## Comments from Industry (I)

2 February 1987

I-1 We have reviewed the draft 1002 Report, particularly those sections dealing with terrestrial biology. Our specific comments are attached. In general, the baseline data collected in ANWR for 1002-related biological studies are of high scientific merit, summarized in a brief (understandably), but informative fashion, and should be of great value in the decision-making process and for assessing development-related impacts. In our opinion, most issues regarding potential impacts have been adequately defined, with the exception of the probability for direct loss of habitats and populations. Sections on "The Effects on the Biological Environment", especially in regard to loss of coastal insect relief for caribou and staging habitat for snow geese, need considerably more support from existing data. At a minimum, more detailed explanations of the criteria and rationale used for estimating habitat loss, amounts of displacement, and population declines are necessary. Without these elements, the impact assessments lack credibility.

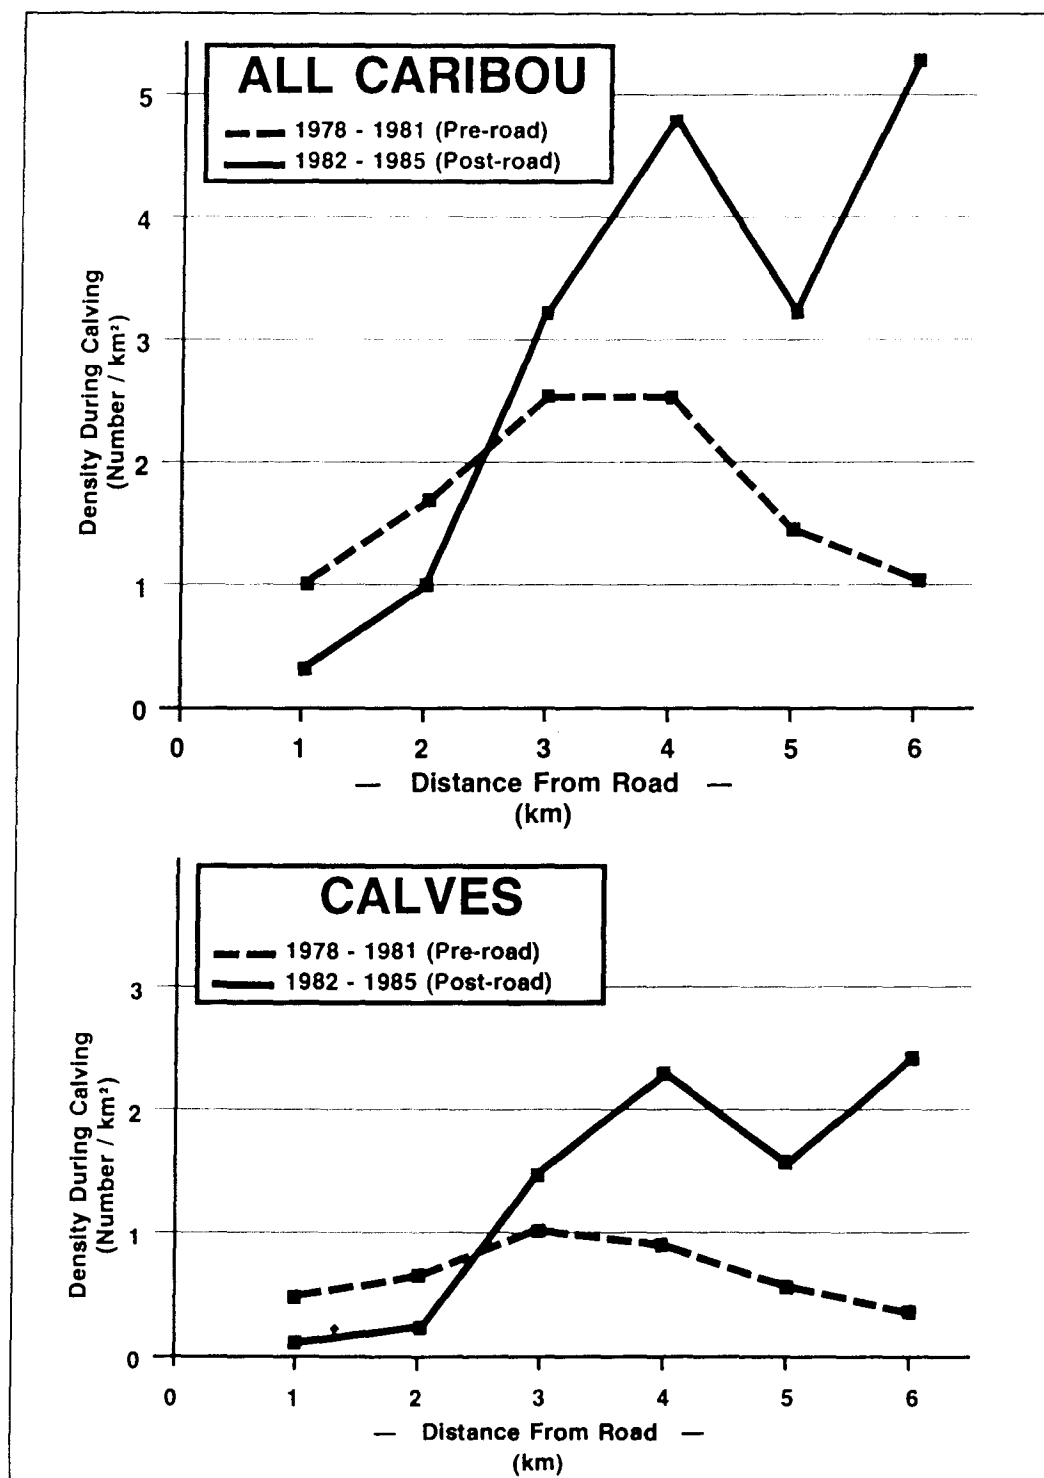
1. In both four-year periods, the data from 1-3 km show the same trend, i.e. increasing density away from the road alignment. The fact that this trend existed both before and after the road was constructed suggests that some other factor (e.g., topography) may have influenced the distribution of caribou.
2. The densities shown for the 1-3 km interval are the four-year means; no information on year-to-year variability is given. Assuming that there was a normal amount of variability, it is almost certain that the data from both four-year periods overlap and are not statistically different.
3. The real differences in the data sets appear to be in the 4-6 km interval.
4. From inspection of the curves, it is apparent that there were roughly twice as many caribou in the study area (i.e., the 1-6 km zone) following road construction than before.

What explains the pattern seen in Figure 6? It is impossible to know. Dau and Cameron's (1985) study is too unclear to permit a conclusion to be drawn, and there is no scientific basis to conclude from their study that any displacement of caribou resulted from the road and associated activity. If the numbers out to 6 km are compared, it is clear that there were about twice as many caribou in the area after the road was constructed than there were

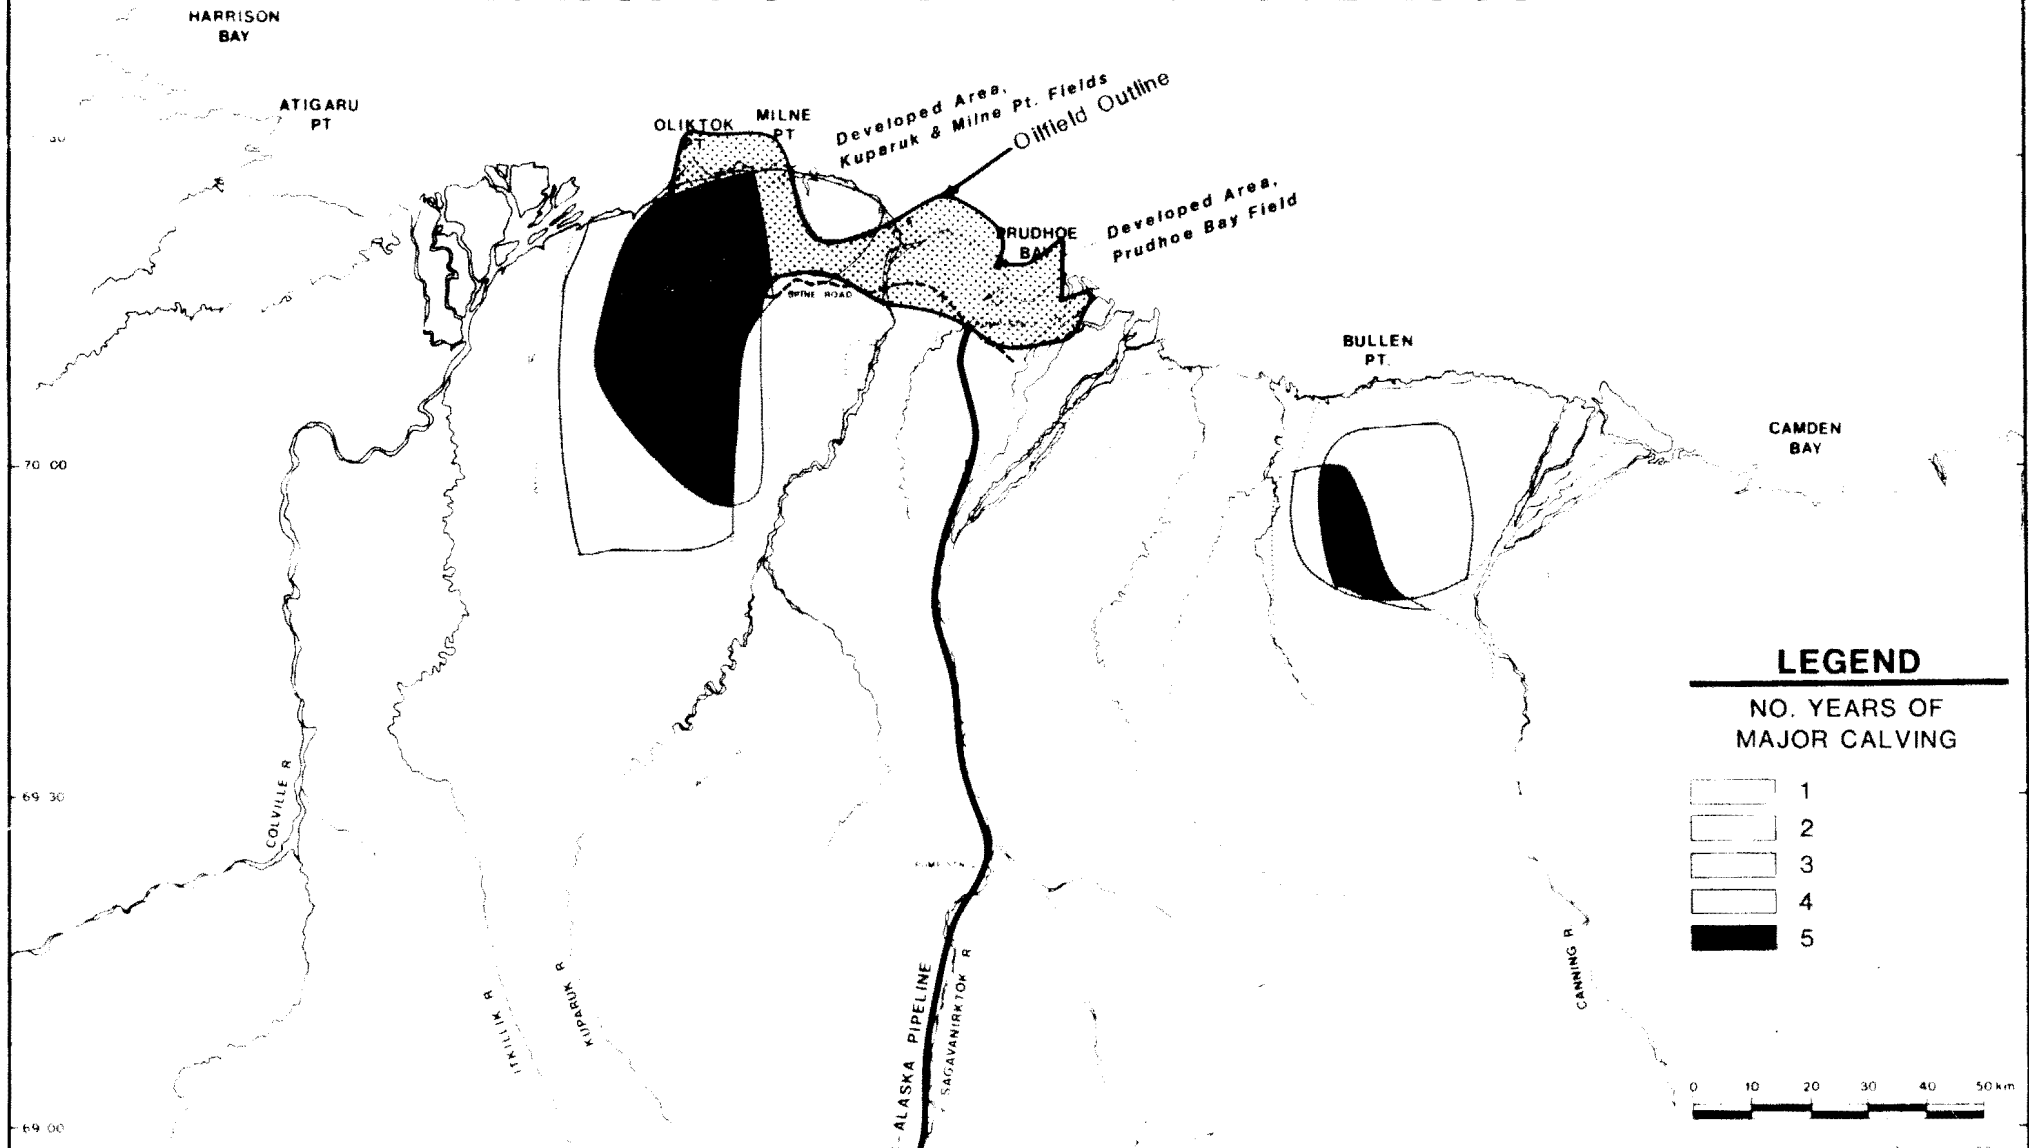
During the period 1981-1986 surveys of the calving distribution of the Central Arctic Herd have been conducted (RRCS, 1985; R.M. Jakimchuk 1986, pers. comm.). Figure 7 shows areas of major usage by calving caribou. It is clear that although calving densities may be lower immediately adjacent to areas of active oilfield operations, caribou continue to calve in the region where they have traditionally done so.
